Subject: Comments/suggestions/questions on landscape plan for Mill Plaza development

From: John Parry, 5 Denbow Rd., Durham, NH

Photo Caption: Parking lot at Greenland Target store with 10 foot islands.

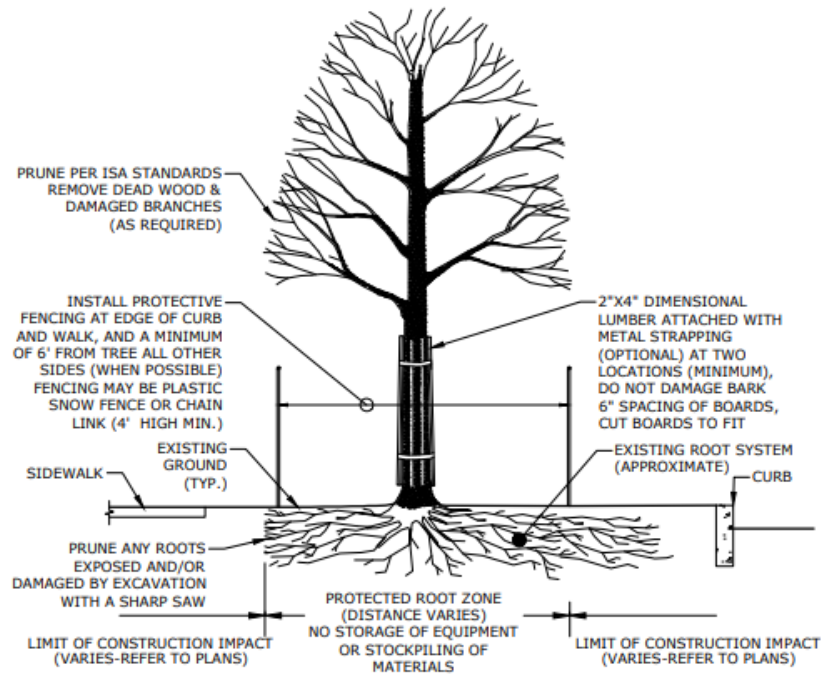
- The islands are 6 feet wide. My understanding is that measurement is to the outside of the curb, so the curbs will take up about 12+ inches of the island space. That **leaves just 5 feet or less of soil width for tree rooting** within the islands. Most tree roots naturally grow horizontally from the root ball. The species selected can grow to a larger size at maturity if adequate rooting space is available. Trees in the existing lot, and on main street are examples of what happens long term without adequate rooting space – they grow slowly, stay small, have poor health, are short lived and must be replaced regularly. I am glad to see species were selected that will have a larger size at maturity, but I feel **the width of the Islands should have been increased (to 8 feet or more) to allow adequate rooting space.** As an example, the picture below shows a parking median at Targets in Greenfield with a 10 foot width and healthy trees growing at a good rate. Wider islands might also allow planting one or two additional trees in each island.

1 PROTECTION FOR EXISTING TREES

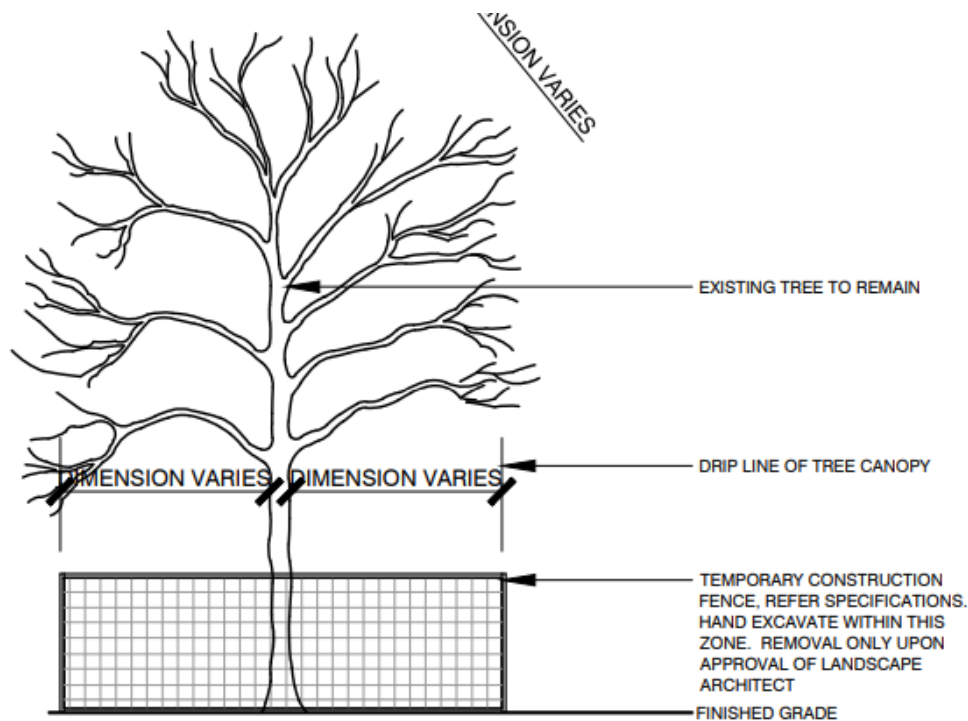
It is difficult to see on the plan which trees are identified for protection? I believe some are along Mill Rd. There could also be some in the College Brook area and along the north boundary of the property. Ideally the **Town Tree Warden should identify and flag trees to protect in the planning stage.** Can we **ID on the plan which trees will be protected and how?**

- Protecting root zone around the tree is critical. Fencing at the drip line is an accepted industry standard* (There are also other accepted methods for determining the root area to protect). The wording in 17. above “or at an **8 foot minimum**” is **contradictory and not adequate** for larger trees over 8” in diameter.
- There are **two different diagrams in the plans** showing different levels of tree protection (see below). The first figure below (from Sheet C508) shows fencing at 6 feet. The **protection standards for existing trees are confusing and need to be clarified.**

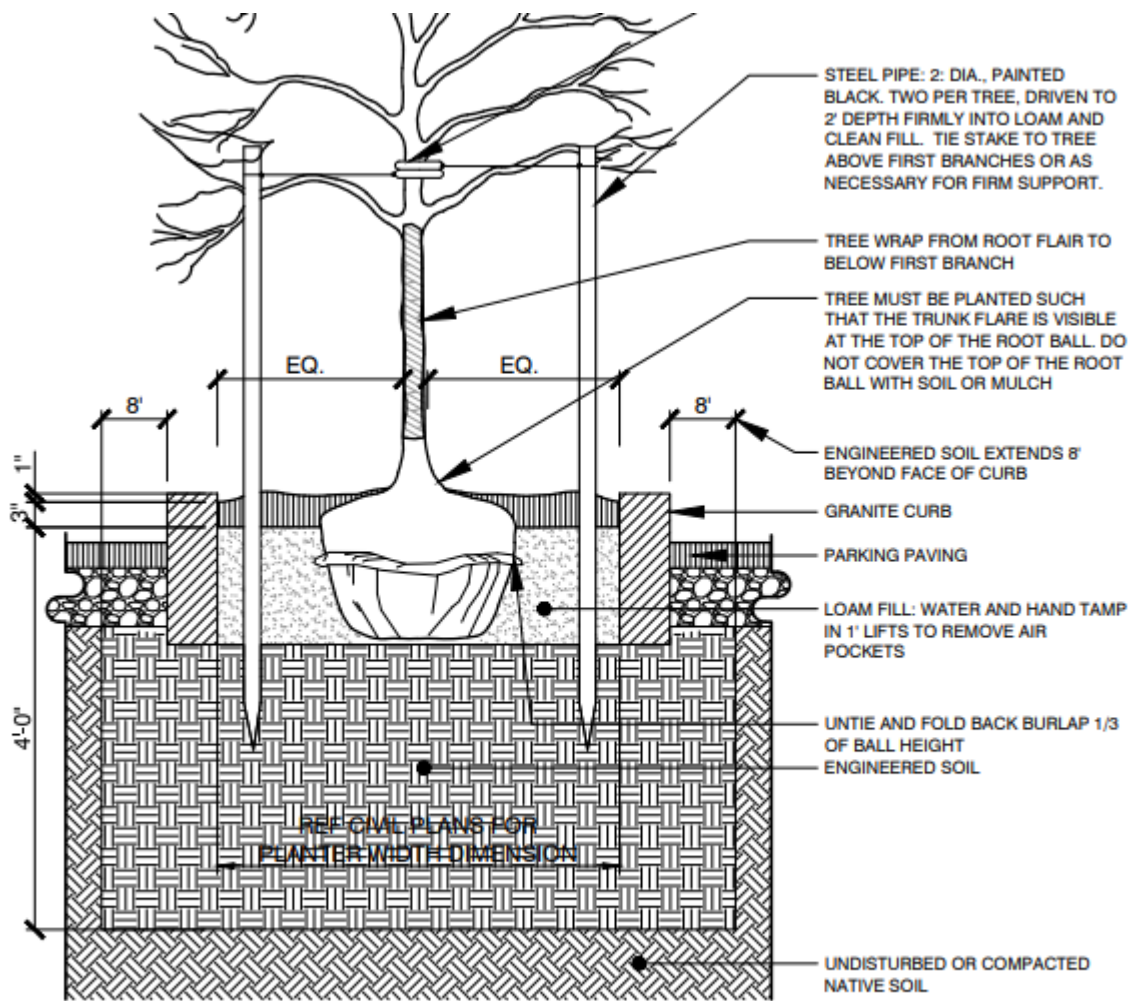
- The crown spread of some of these trees at maturity shows as up to 30' plus. **Need to plan adequate spacing in the parking lot islands to avoid branch conflicts with pedestrians, vehicles, delivery trucks, snowplows**, etc. Branches can be pruned up over time*, but trees must be allowed to gain height before too much lower branch pruning can be done. Good species selection can help. Also, when ordering trees from nursery, contract wording can specify the height to which trees should be free of branching.

- Landscape Note 14. on the plan states; PARKING AREA PLANTED ISLANDS TO HAVE MINIMUM OF 1'-0" TOPSOIL PLACED TO WITHIN 3 INCHES OF THE TOP OF CURB ELEVATION. REMOVE ALL CONSTRUCTION DEBRIS BEFORE PLACING.
Ideally loam should be as deep as the tree root balls (approx. 24"?). Might also consider replacing the engineered soil under the trees with loam soil (see comment below under engineered soil).

- A concern I have is that **any existing, compacted undersoil (underneath the islands) will impede water drainage from the islands**, especially if the old, compacted soil from previous construction is still present. If water drainage is a concern, it would be helpful to break up or till compacted soil, to a depth of 4 feet or more for the whole length of the islands. Engineered soil under the trees may help with drainage, especially if the engineered soil (or an appropriate soil mix) ran the full length of the islands to a depth of 3 - 4 feet. **Another option is to install drainage tile the length of the islands, especially if an outlet can be provided. This could be a cheaper alternative to other remedies.**

4 DECIDUOUS TREE PLANTING: CENTER PARKING ISLAND
 Scale: Not To Scale

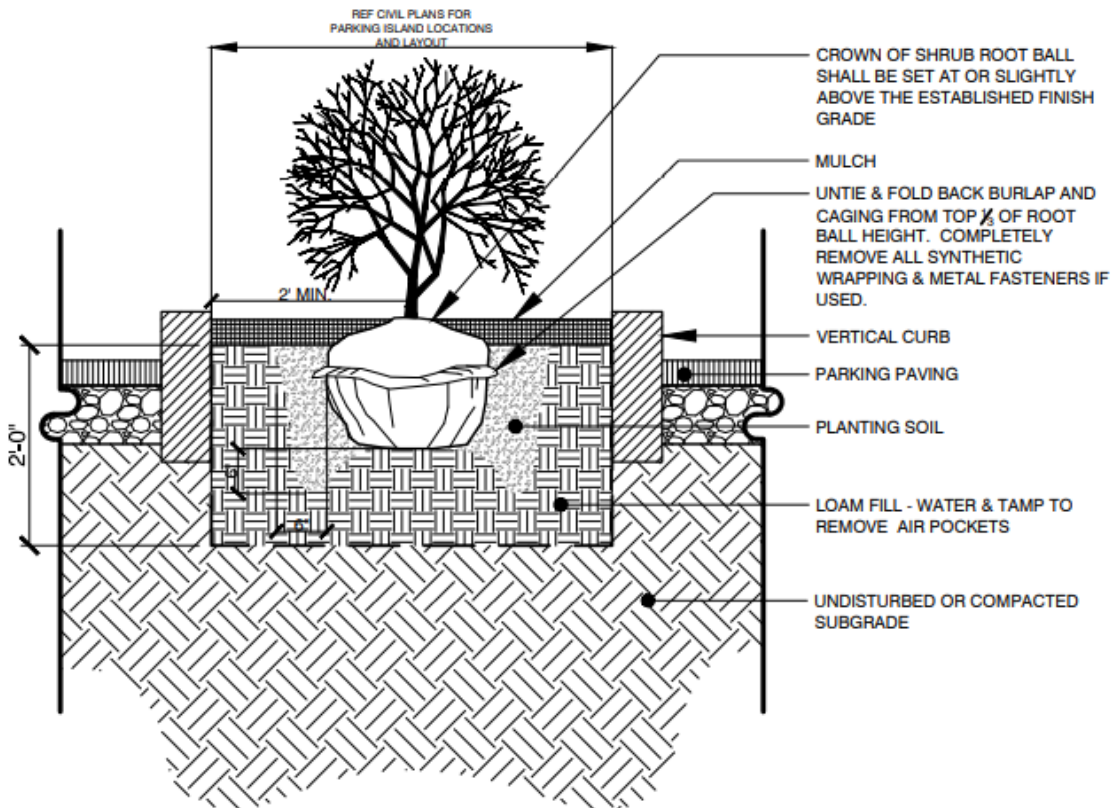
- Most tree roots grow laterally from the root ball, and stay in the top 2 - 3 feet of soil*. Your diagram below shows that the island curbs will be at the same level as the root ball, forcing the roots to grow down and under the curb to get to the ES under the pavement. Roots will likely do this, but perhaps to a lesser extent (especially at a 4 foot depth). **Is there a design change that could improve lateral growth of the roots into the ES under the pavement?**

- There is **no engineered soil shown under the planned shrubs in the island, so that implies that the engineered soil does not run the full length of the island** and is only near the trees? **It would be useful to know how far the engineered soil extends on either side of the trees.**

- The tree planting figure above shows the root ball planted high, about $\frac{1}{4}$ of the root ball is above the soil. **I feel this is inappropriate. Trees should be planted so that the root flare is established at or near ground level.** If soil settling is a concern, trees can be planted slightly high (no more than 1 – 2 inches high). The **ANSI standard for tree planting** (ISA Tree Planting BMPs – Companion Publication to ANSI A 300 Part 6) states that “B&B root balls should have the trunk flare correctly located at the surface – the planting hole can be 1 -2 inches shallower than the root ball depth in anticipation of minor settling and flattening of the root ball”*.
